SITE PLAN REVIEW AND APPEARANCE BOARD

CITY OF DELRAY BEACH

---STAFF REPORT---

ITEM: **The Flossy Building** - Class V Site Plan, Landscape Plan and Architectural Elevations associated with demolition of the existing site and construction of a new 2-story mixed-use development with 6,540 sq. ft. of retail on the ground level and residential on the upper levels. (124 NE 5th Avenue)

Architectural Site Plan
Data Sheet

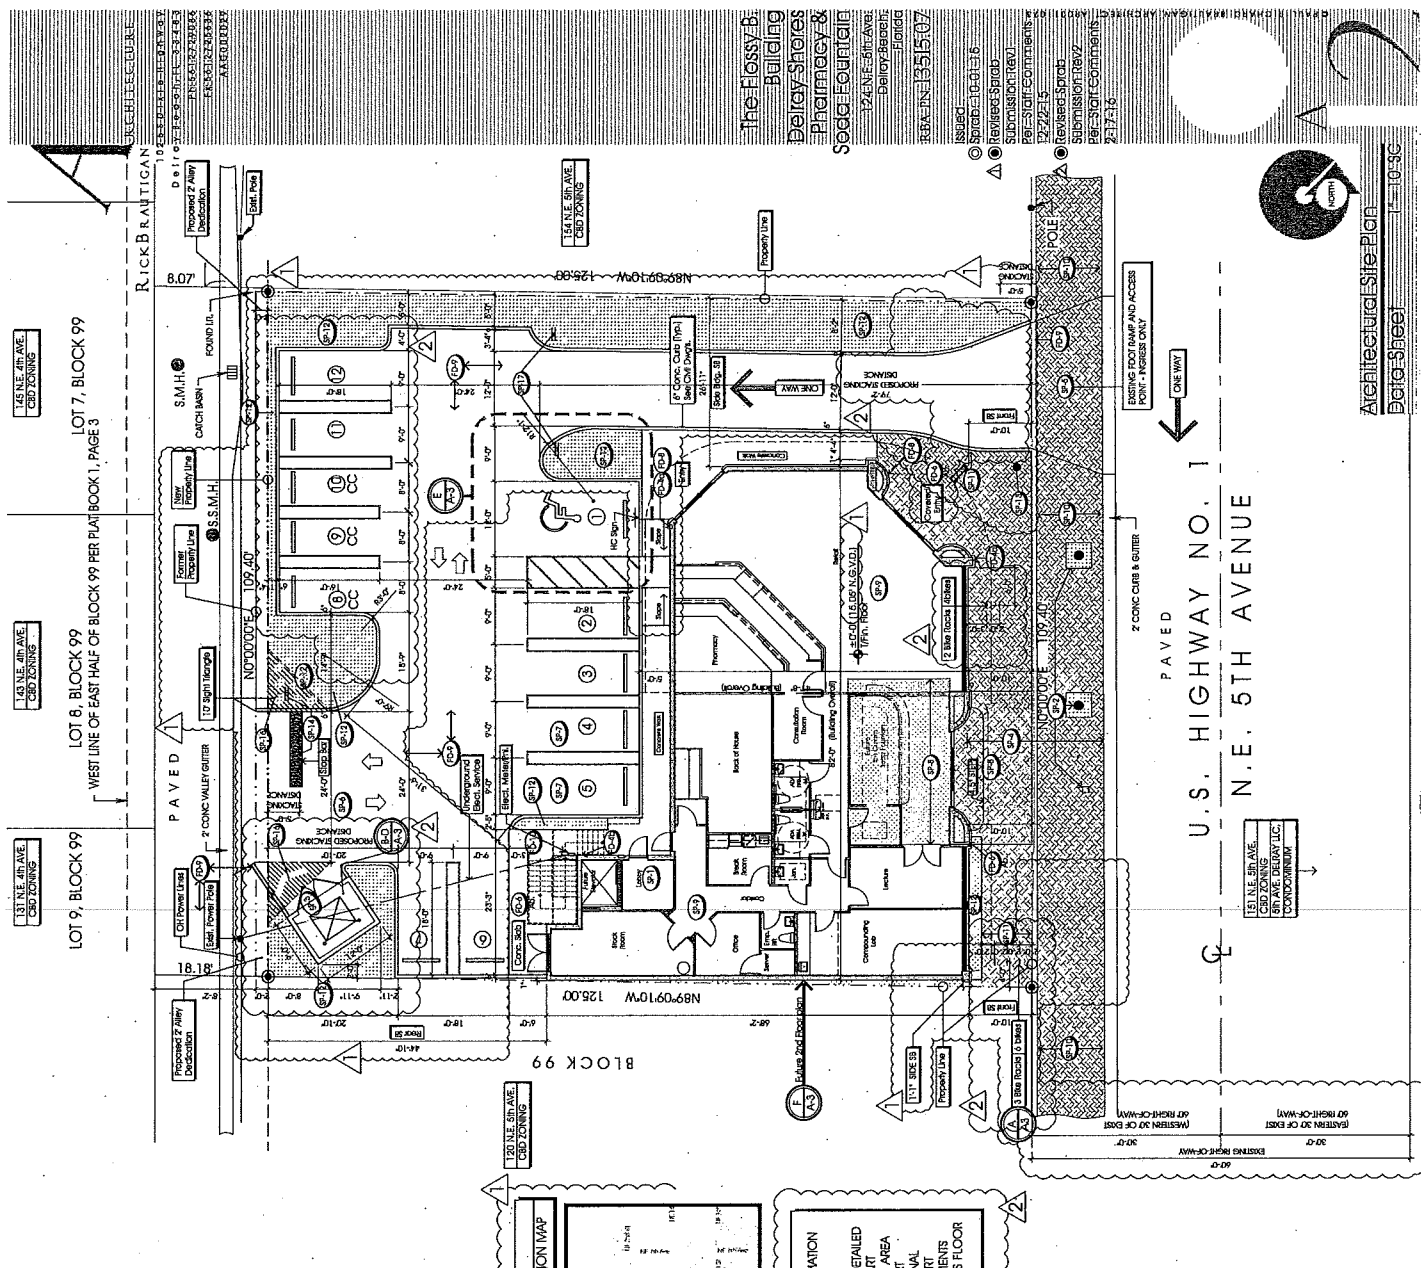
* For Table 4.4.13(C) above, the items identified in **BOLD** are compliant. However, the plan notations must be updated.

Since the current location and position the proposed dumpster enclosure may potentially conflict with ingress and egress from the two-way 24' drive aisle, provision of a truck turning template to demonstrate how the dumpster truck will maneuver in and out of the alleyway to accommodate regular trash pick-up is requested. Pursuant to LDR Section 4.6.6(C)(1), dumpsters, recycling containers and similar service areas must be enclosed on three (3) sides with vision obscuring gates on the fourth side, unless such areas are not visible from any adjacent public right-of-way. The dumpster detail indicates that this requirement has been met. However, provision of the dumpster truck detail is attached as a condition of approval. Upon doing so, this LDR requirement will be met.

demonstrate how the dumpster truck will maneuver in and out of the alleyway to accommodate regular trash pick-up is required, prior to certification of the site plan.

Front Elevation (East) 1/4" = 1'-0"

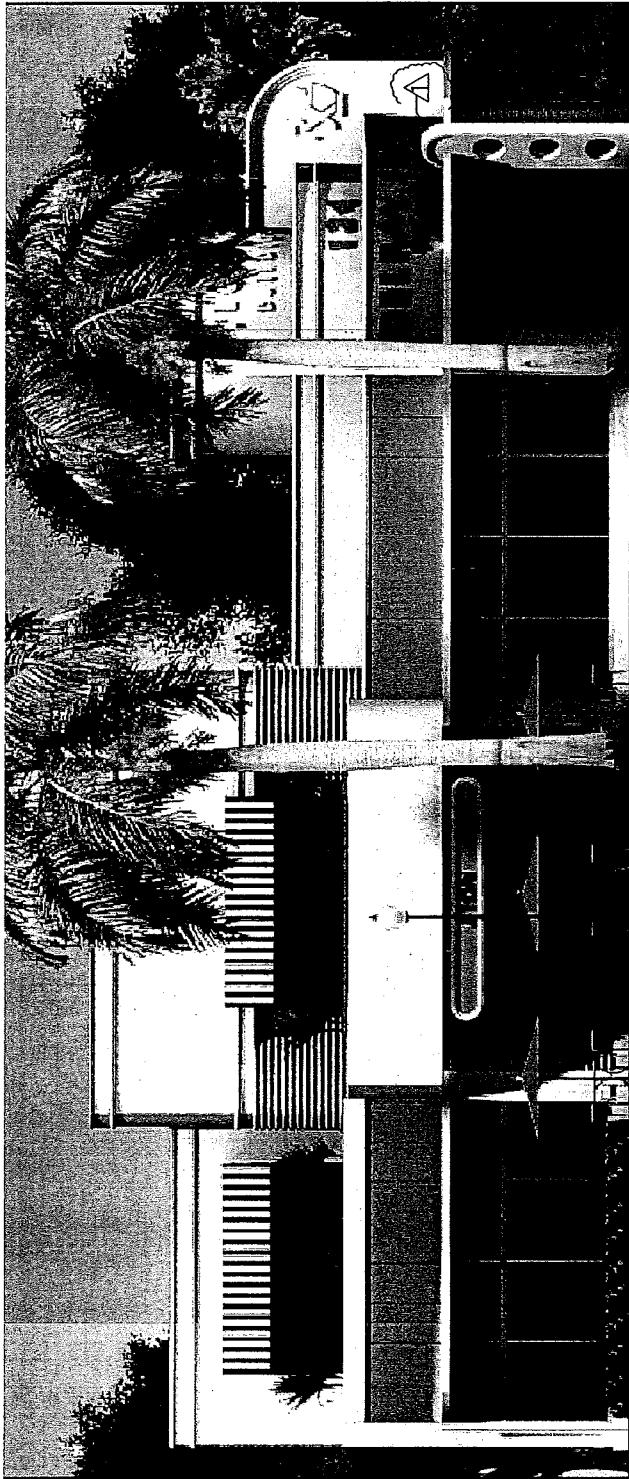
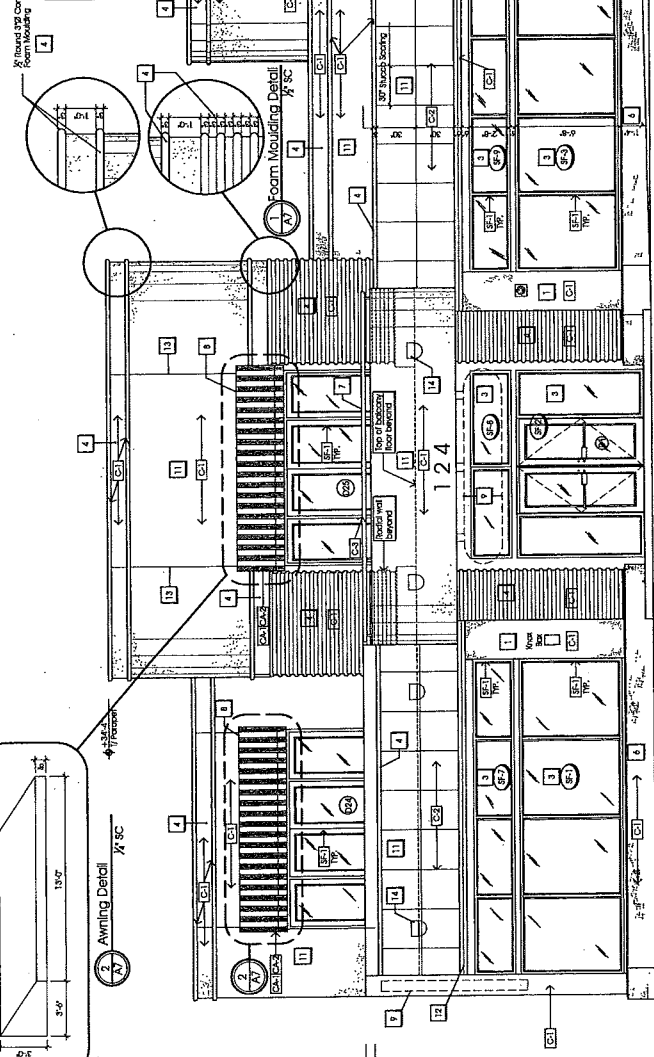
While it is not explicitly stated in the most recent updates to the LDRs and architectural guidelines, ongoing discussion regarding the discouragement, and potential prohibition of "foam moulding" continues, due to its lack of long term durability. As such, staff is recommending that this feature element be modified to reflect stucco banding or an alternate material to produce the desired visual effect proposed by the "foam moulding". This is a staff recommendation that is at the Board's discretion. However, it is recommended as a condition of approval for the proposed architectural elevations.

1. Replace the “foam moulding” with an alternate material or design that exhibits a similar visual effect (i.e. stucco banding) and has long term durability. This feature element is not preferred and is inconsistent with the recently established CBD architectural design guidelines.
